RE: JMC Project 20101
The Summit Club at Armonk Residential
Bedford Road (Route 22)
Town of North Castle, NY

Response to Town Comments Resubmission

Town of North Castle Planning Department, dated June 22, 2021

ROAD A FIRE TRUCK TURNING ANALYSIS
SCALE: 1" = 50'

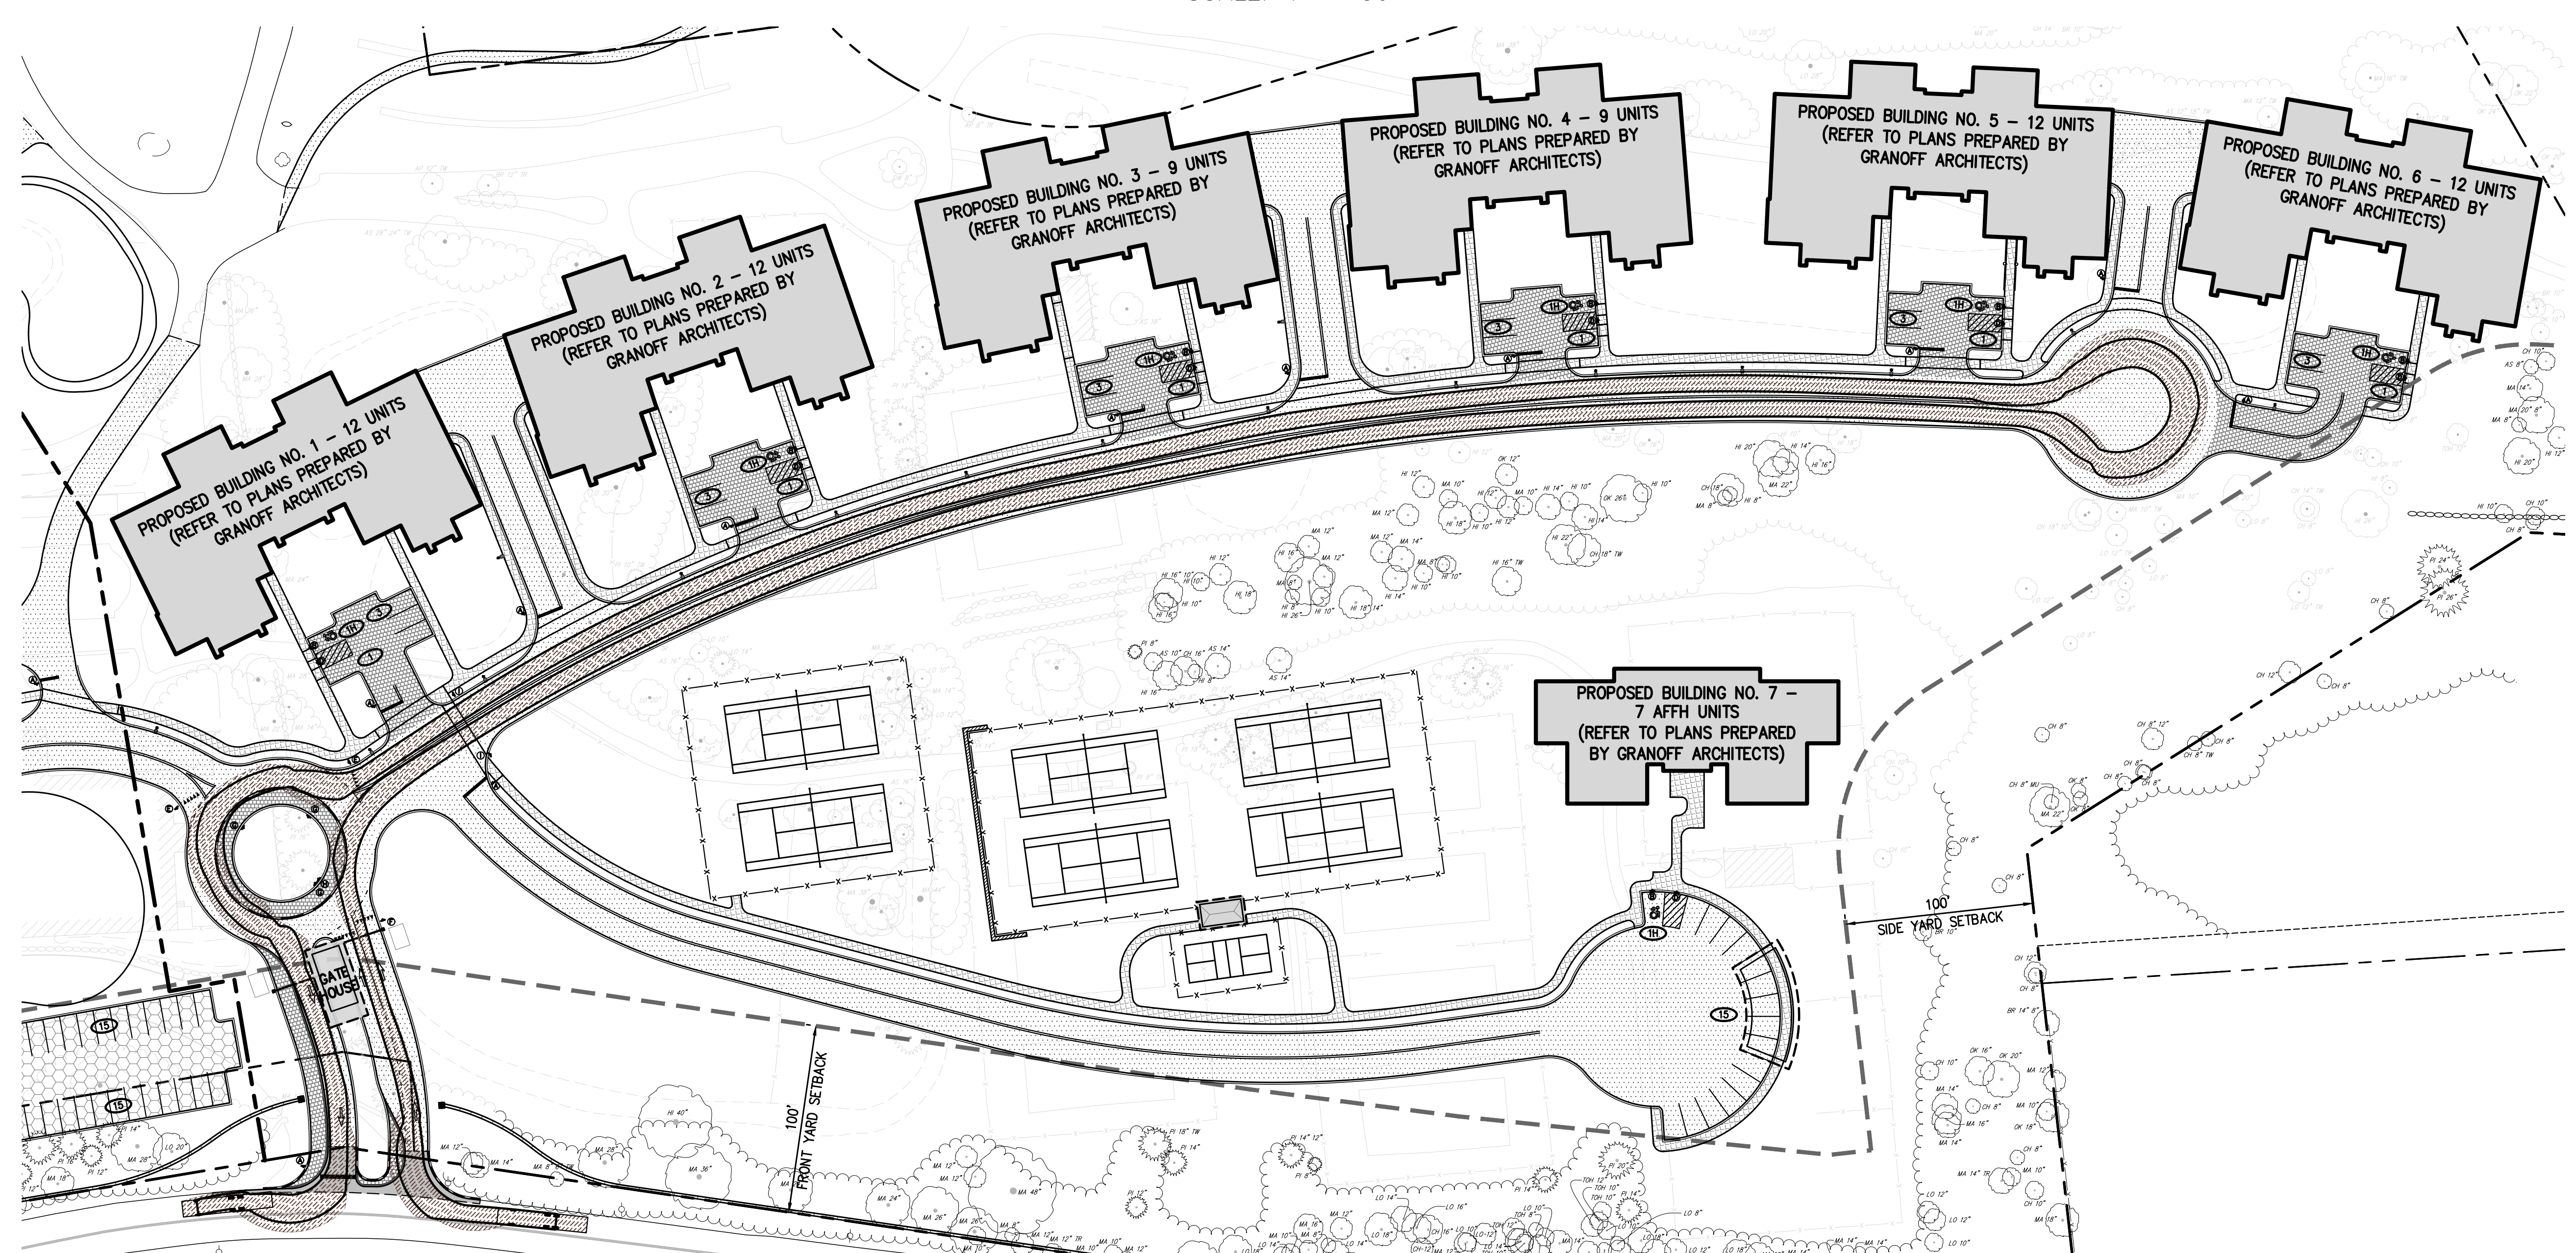
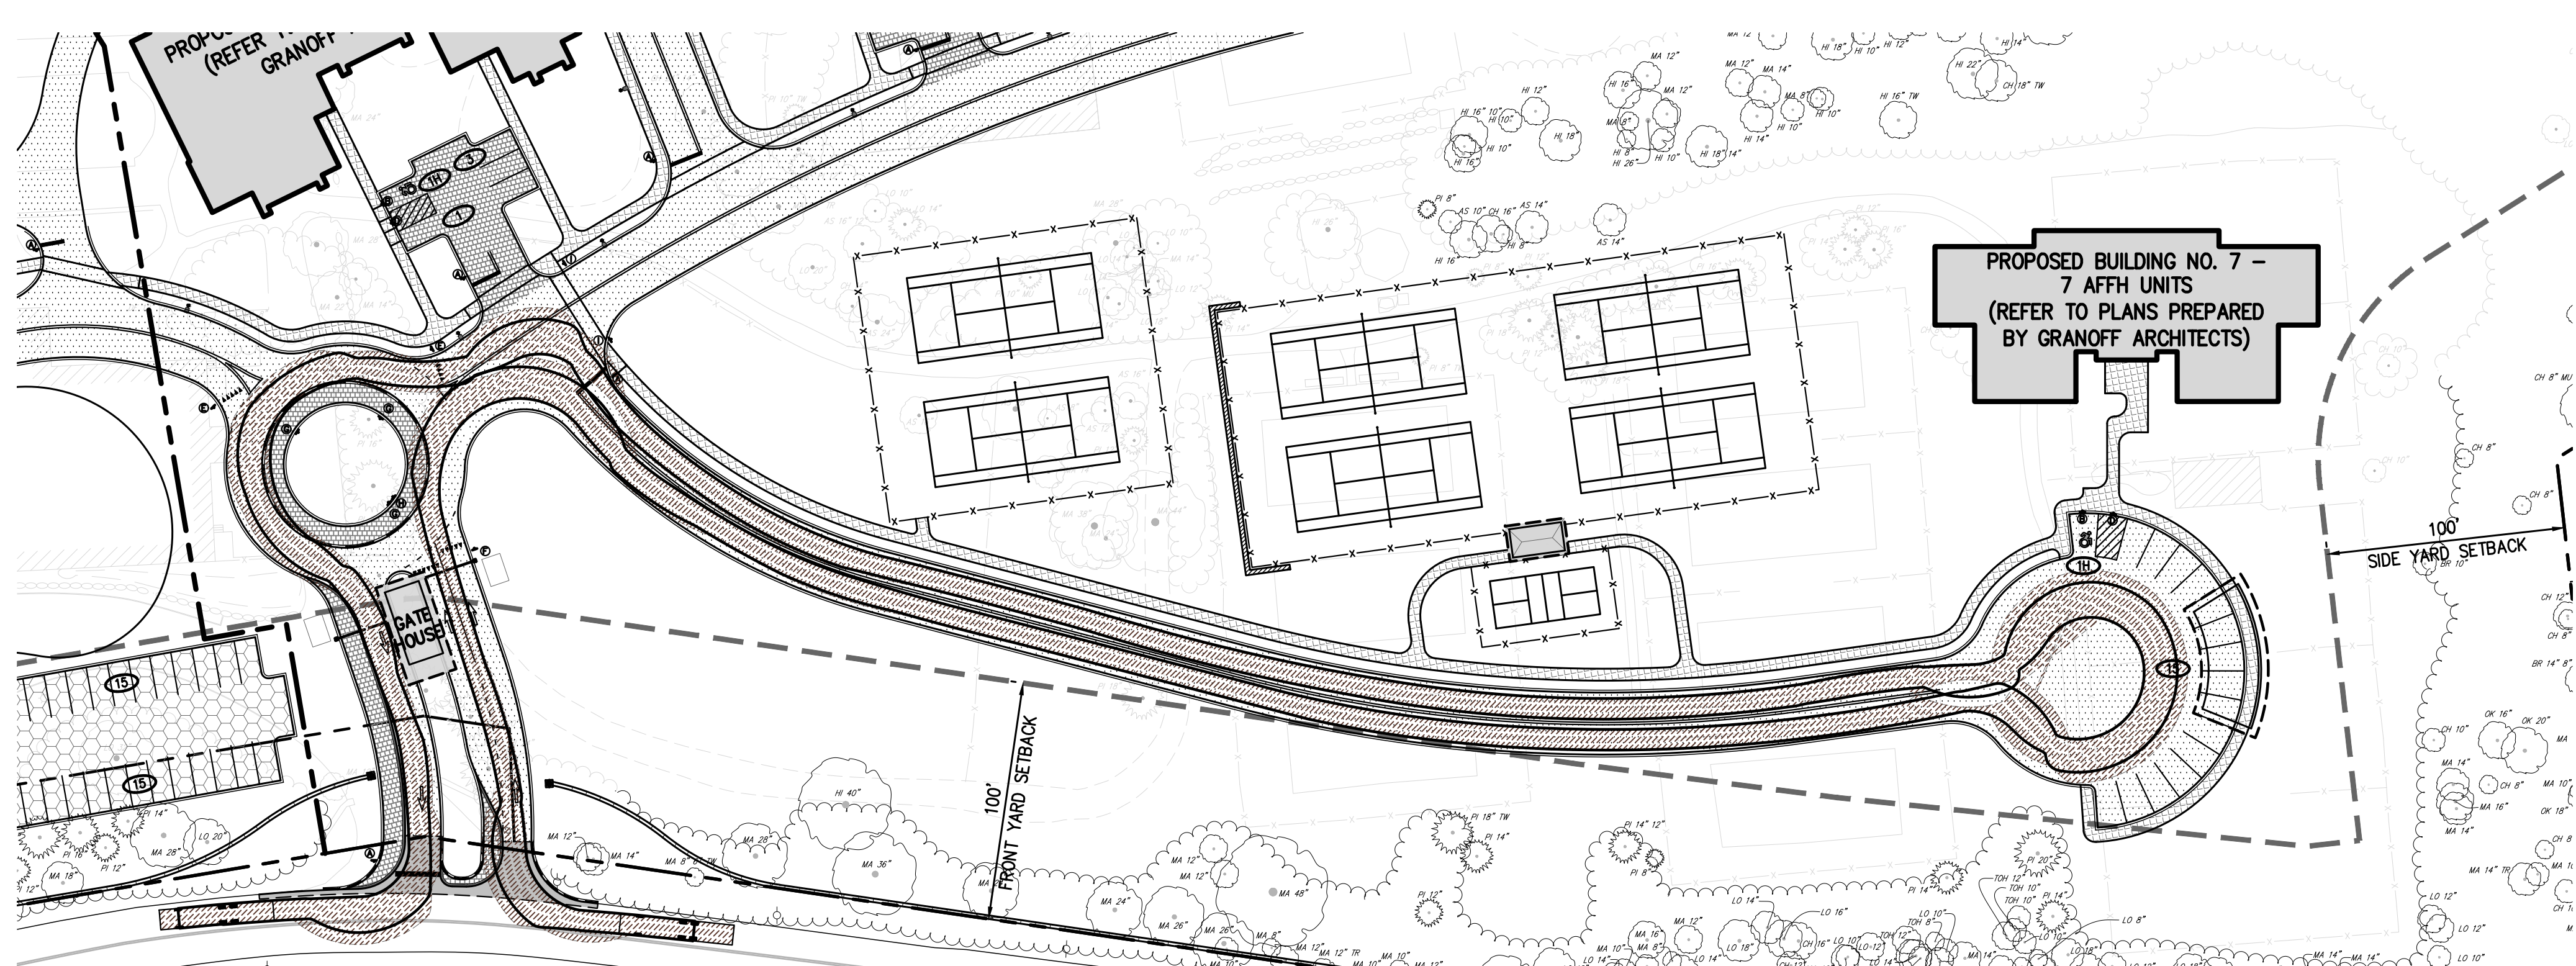
The applicant has provided fire truck turning movements along proposed roadways and driveways through the project. The only apparent conflict is at the end of Road "A" where apparatus exiting the parking lot traverses over the three (3) parking spaces east of the driveway. The applicant should re-examine this turning movement and show whether the movement can be accomplished when vehicles are parked within these spaces. We would recommend that the plan be referred to the Armonk Fire Department for review.

The fire truck turning analysis has been revised to avoid conflict with parking spaces.

OSTP TO SMH-4 PROFILE
 HORIZONTAL: 1" = 30'
 VERTICAL: 1" = 10'

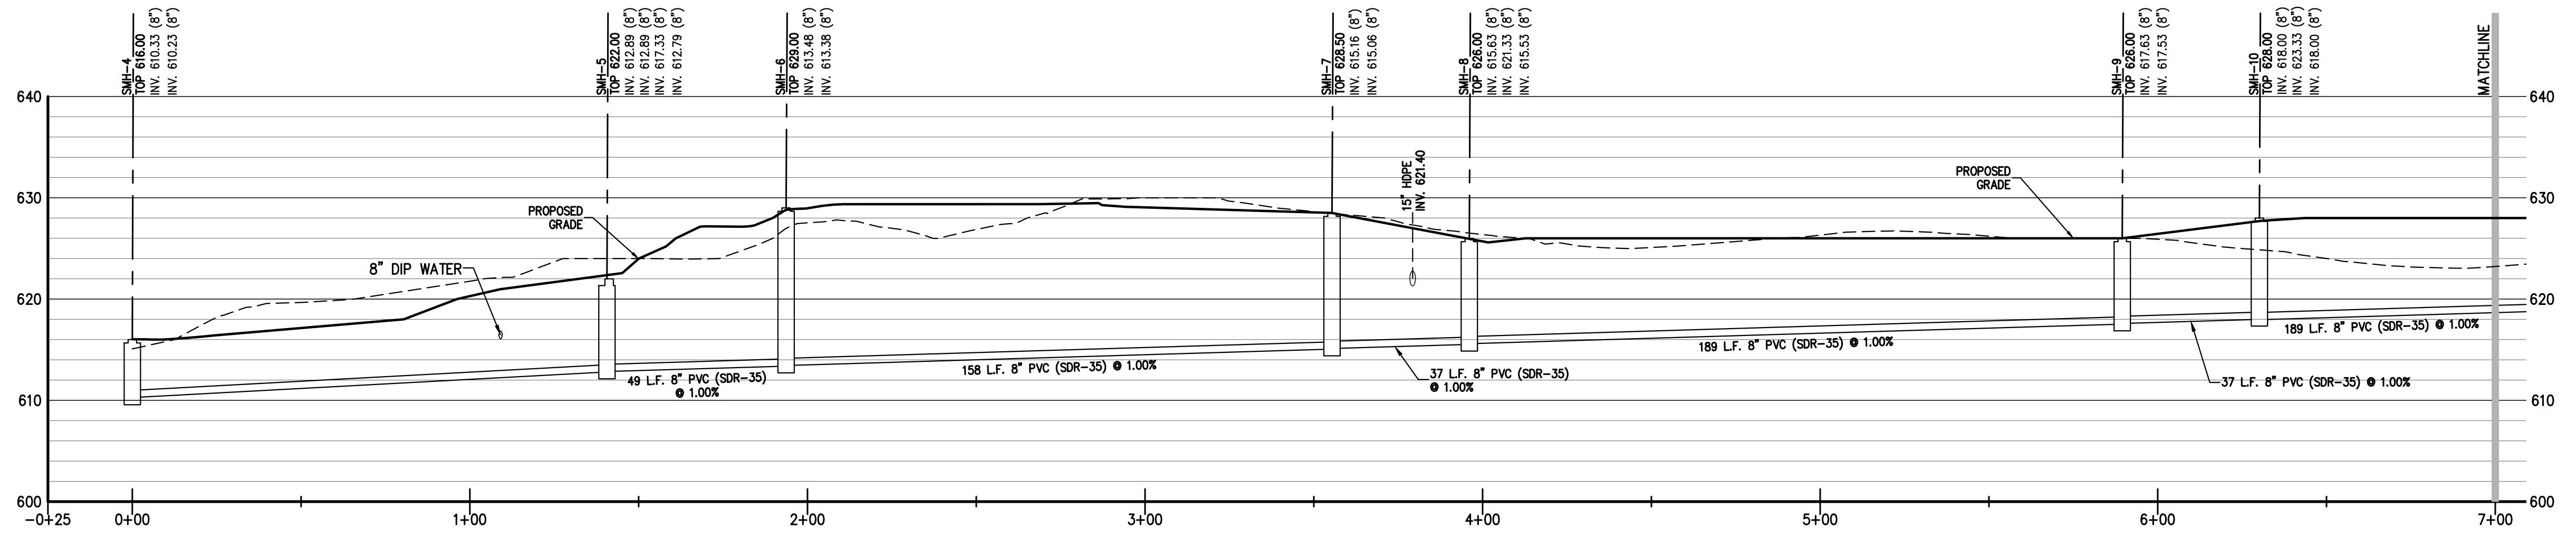
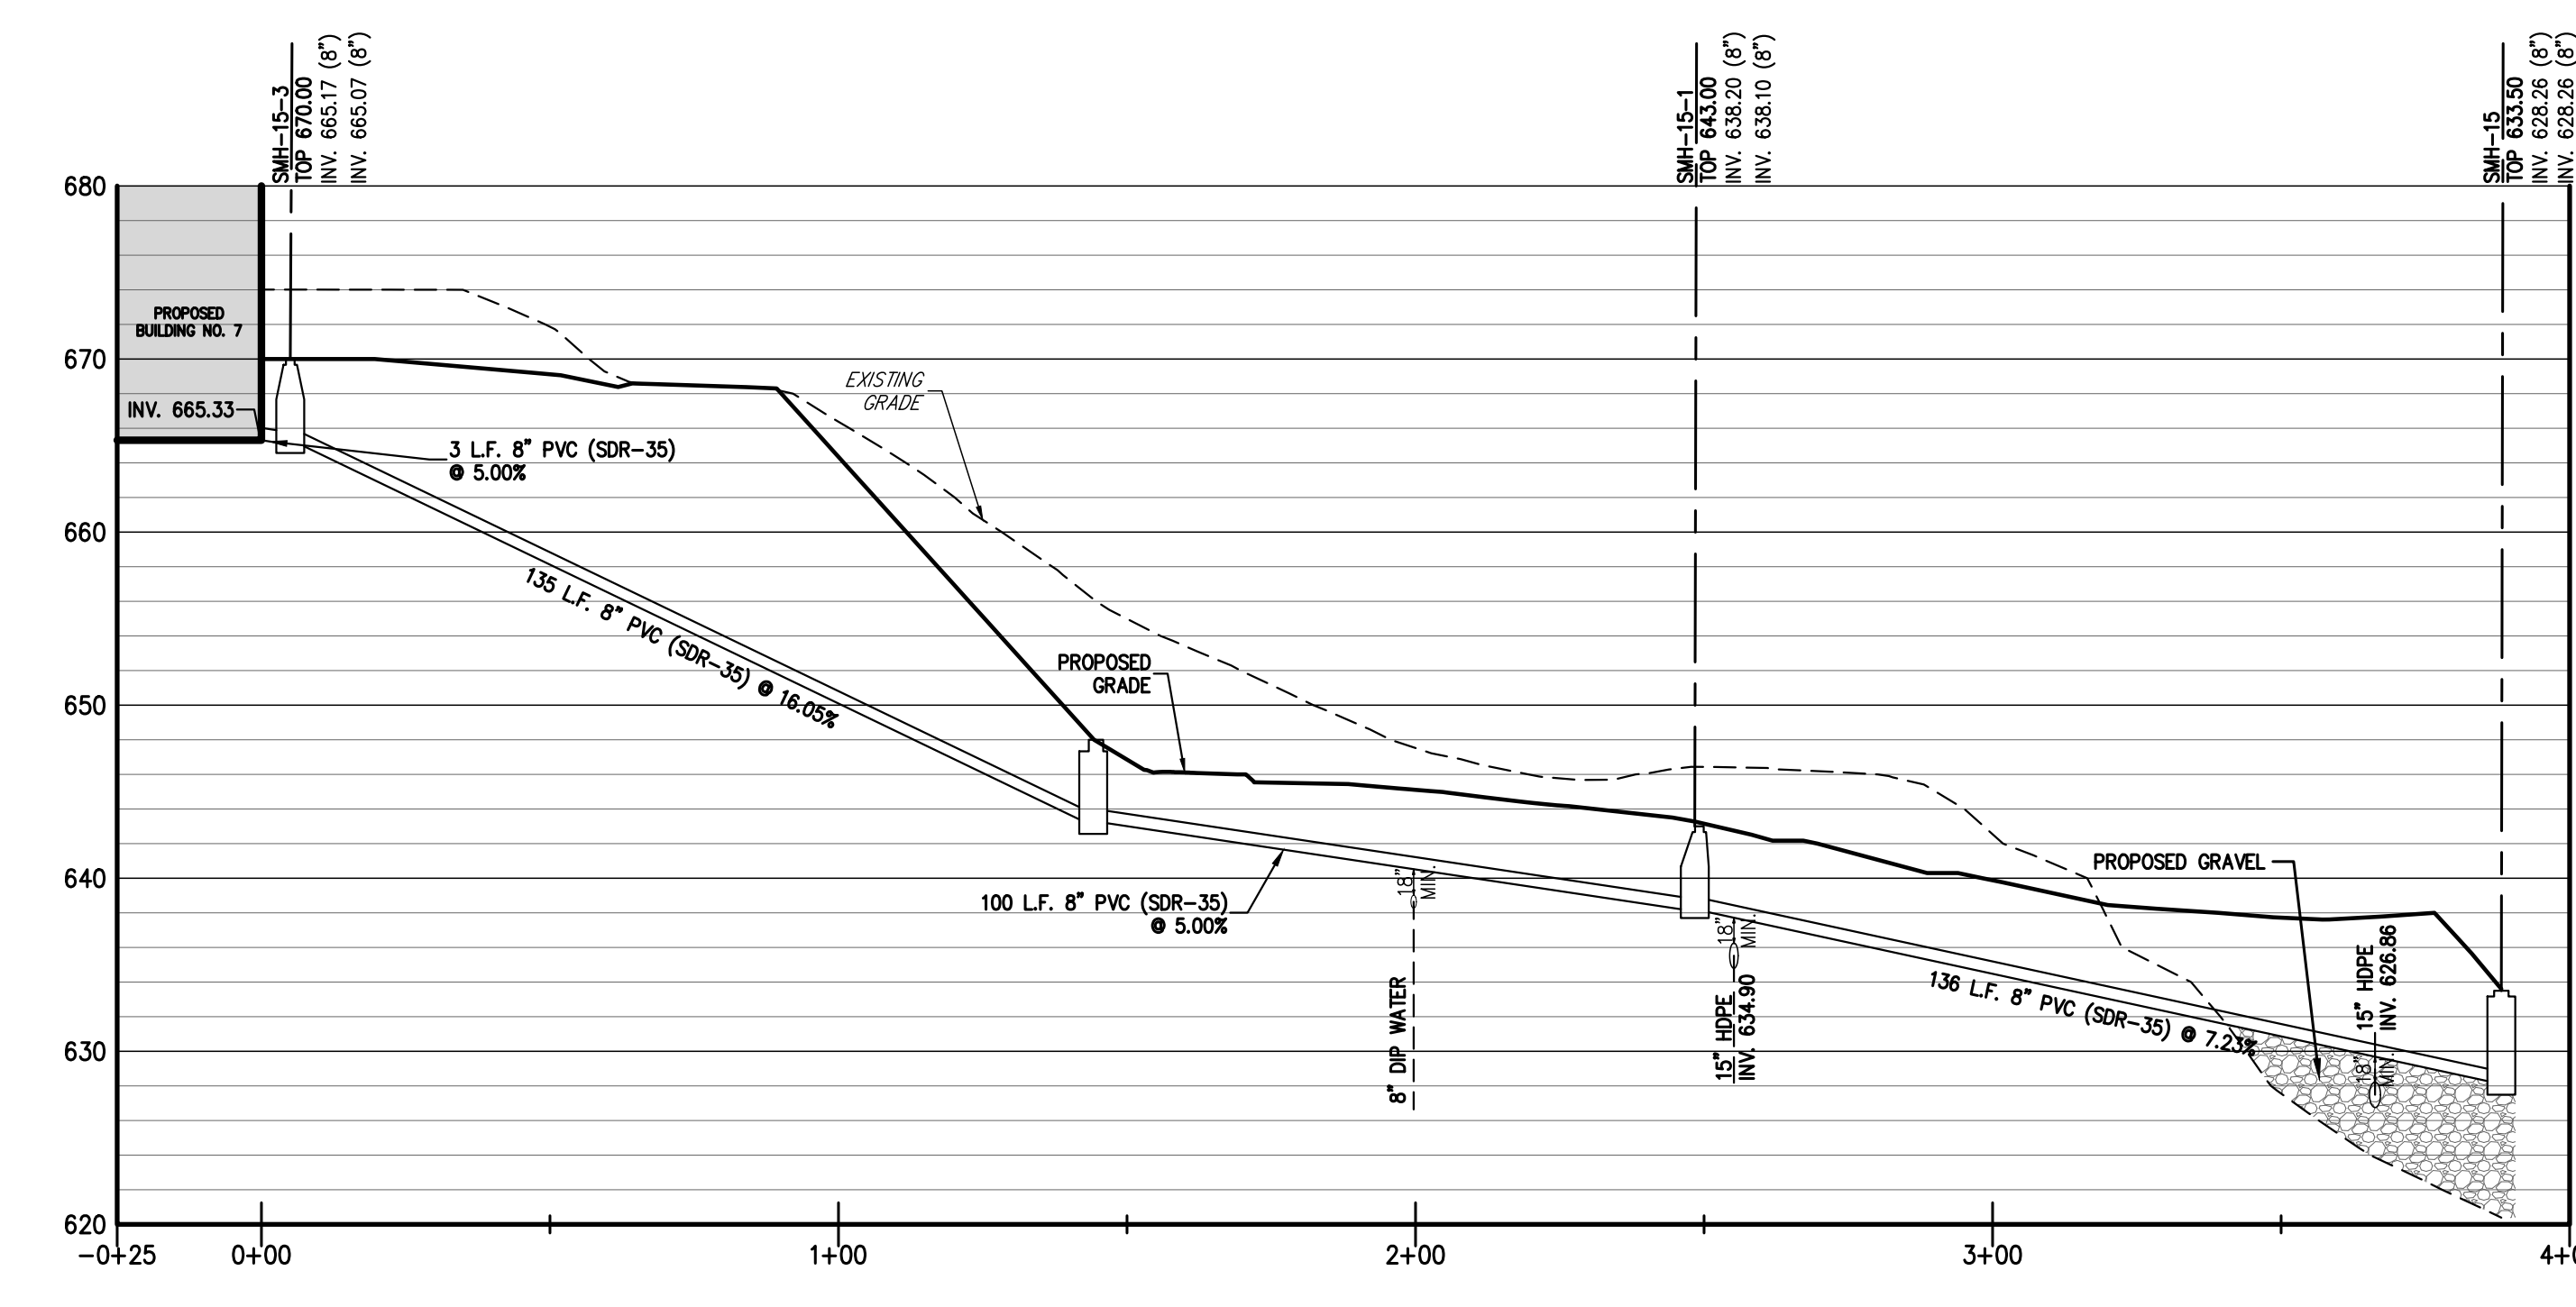
The sewer main within the rear of the residential buildings also appears to be excessively deep, with significant portions of the main in excess of 20 feet deep and a manhole at 22 feet deep. The depth of installation could be reduced significantly with some minor changes to the grading plan at SMH 15 and 13 and also within a short segment of the main between SMH's #11 and #12. Also, if the sewer main were constructed between manholes BMH #3 and SMH #7 instead of SMH #4 and SMH #7, further reductions of depth may be achieved.

The sanitary sewer and associated grading have been revised to reduce the proposed overall depth.
